Seattle Design Commission

MINUTES OF THE MEETING

February 07, 2008

Projects Reviewed

Figure 3: Fire Station 27 elevations

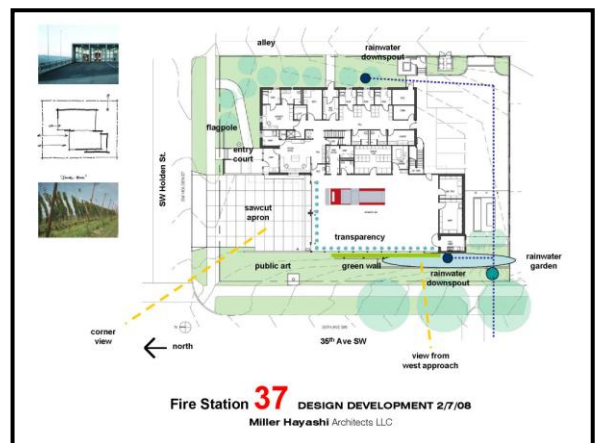
- What are the angles above the apparatus bay doors in the north elevation?
 - They are part of the structural tension system.
- Are there trusses in the apparatus bay?

- What is the roof protrusion in East elevation?
 - It is a skylight on the roof.
- The building will have a dramatic civic presence, and should embrace the corner despite the size of the structure.

- The choice in color, materials, and doors are all appreciated. Due to beauty of materials, the team shouldn't cover up too much of the wall with hops.

- The balance of the screen behind the hops is unsettling, front corner could open up to allow more transparency.
- The hops green screen could also angle back at south end to provide view into apparatus bay. Low glazing could be used on the bottom window.

Figure 7: West and South Elevations

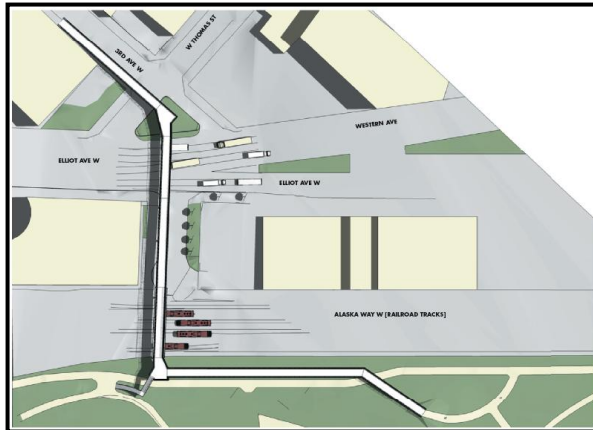
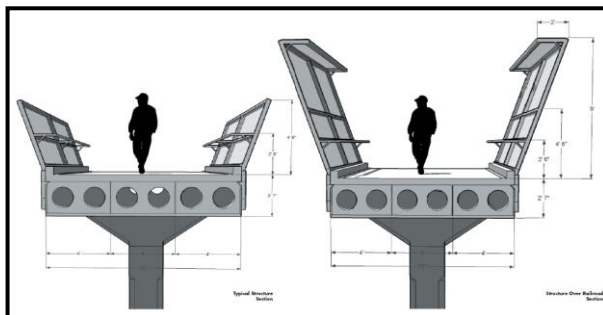
- **Appreciate the quick and thoughtful response to comments from last session**
- **Emphasize priority in this funding go to include the stairs at Elliott Ave. Would like to see these stairs shown in future drawings**

- **Excited about west belvedere into park as an opportunity to create a dramatic space and allow for clear movement and passage around this corner.**
- **Appreciate presenting the design realistically with clear sense of where the money is going**

- **Concerns over railing. Appreciate that it is a work in process. Support having the railing for functional reasons, but must be looked at relative to youth, skateboarders and other concerns**

- **Support minimal lighting plan**
- **Appreciate simplicity of structure, but also recognize it can be brutal.**
- **Recognize the opportunity to humanize structure through art or other means**

- **Expressed concerns about skateboarders and how they will use this structure**
- **Support minimizing the impact of downspouts, and their incorporation into a clear drainage strategy**

- **Recognize there are several neighbors to this project. Structure must meet surrounding conditions as elegantly as possible.**
- **Disapprove of potential for signage to be hung from bridge**

- **Recognize and support importance of bike movement, but continue to have concerns regarding bicyclists or skateboarders traveling fast down the ramp to W. Thomas.**

Figure 9: Project Cross Section

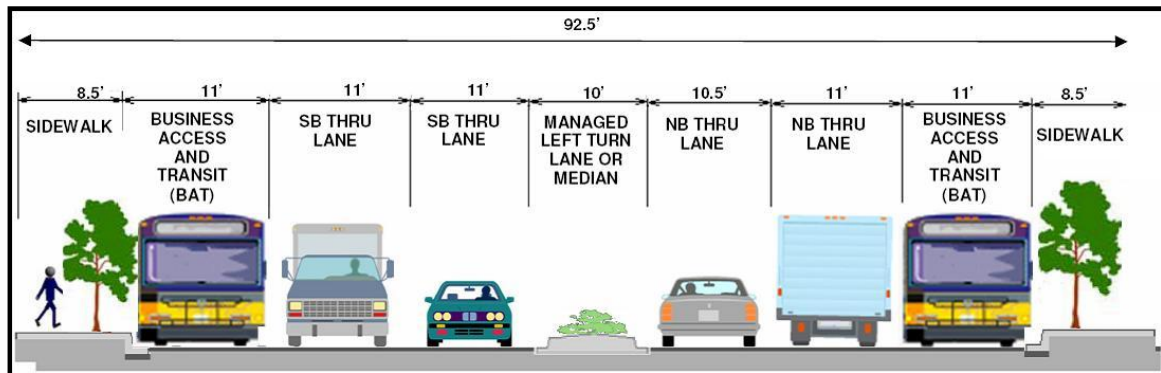
Comment: The proposed design isn't possible in this area. Sidewalks still remain at 12' and bus lanes at 13'. No amendment has been filed by Mayor. The current appeal is on that larger width, but no change to the DNS has been made. In addition, the project has ignored neighborhood concerns. There are currently 1120 multifamily units being built along Linden; no provision for those who travel to Aurora to access sidewalk or bus services.

- The smaller sidewalk is at the detriment of the pedestrian.
 - Where people are waiting for buses the ROW should be kept to provide shelter.
- Linden will be constructed as a pedestrian street

- U-turn every 400' feet
- Concern over U-turns without traffic lights.
 - Once drivers get used to it, it works well.
- Less U-turns at fewer locations
- Access management and balancing with safety and efficiency of roadway is critical. Minimizing left turn pockets will add benefit to roadway and aesthetic, but will jeopardize access.

- Is WSDOT onboard with lane change?
 - They recognize the compromise.
- Safety over amenities, but bus lane needs to be wider. This is one area of Aurora that has many businesses.
